PUBLIC WORKS SERVICE CENTER IMPROVEMENTS
CITY OF ROANOKE
1802 Courtland Road
Roanoke, Virginia

FIELD REVISION #10 - SMW STORAGE BUILDING DRAINAGE AND GRADING REVISIONS

SHEET
FR-10

GRADING PLAN
Scale 1" = 30'

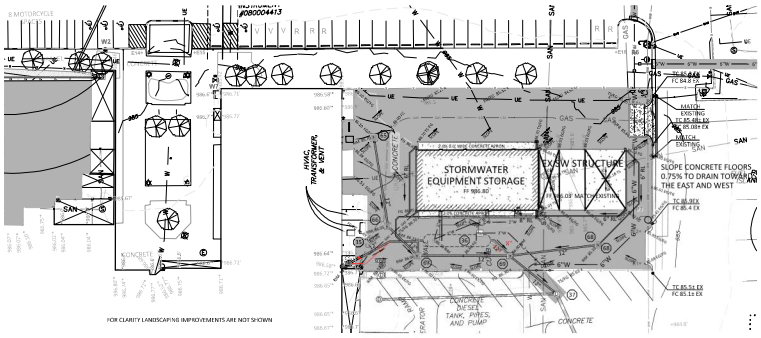
STORM SEWER SYSTEM NOTES:
1. THE UTILITIES SHOWN IN THEIR APPROXIMATE LOCATION. NOT ALL UTILITIES SHOWN.CONTRACTOR SHALL VERIFY.
2. CORE NEW OPENING IN STRUCTURE MH-37 (EXIST. D-35)

65	VDOT STD. D4-1 TOP ELEV. 985.80' INV. OUT 982.30'	H=3.5'± (12")
66	VDOT STD. D4-1 TOP ELEV. 986.05' INV. IN 981.00' INV. OUT 981.00'	H=5.0'± (12") (12")
65 - 66	55'± - 12" PIPE INV. IN 982.30' INV. OUT 981.60'	S=1.2%±
67	VDOT STD. D4-1 TOP ELEV. 986.00' INV. IN 978.80' INV. IN 980.32' INV. OUT 978.70'	H=7.3'± (12") (12") (12")
66 - 67	24'± - 12" PIPE INV. IN 981.00' INV. OUT 980.32'	S=2.4%±
68	VDOT STD. D4-1 TOP ELEV. 985.10' INV. IN 982.00' INV. OUT 981.95'	H=3.60'± (5") (12")
69	VDOT STD. D4-1 TOP ELEV. 986.00' INV. IN 977.87' INV. IN 981.00' INV. IN 982.00' INV. OUT 977.77'	H=8.2'± (12") (12") (12") (12")
67 - 69	57'± - 12" PIPE INV. IN 978.70' INV. OUT 977.87'	S=1.4%±
68 - 69	55'± - 12" PIPE INV. IN 981.55' INV. OUT 981.00'	S=0.9%±
37	EXISTING D-35 TOP ELEV. 985.99' INV. IN 977.29' (12") CORE NEW OPENING IN EX. STRUCTURE	
69 - 37	30'± - 12" PIPE INV. IN 977.77' INV. OUT 977.29'	S=1.2%±

DRAINAGE DESCRIPTIONS (REVISED AND ADDITIONS)
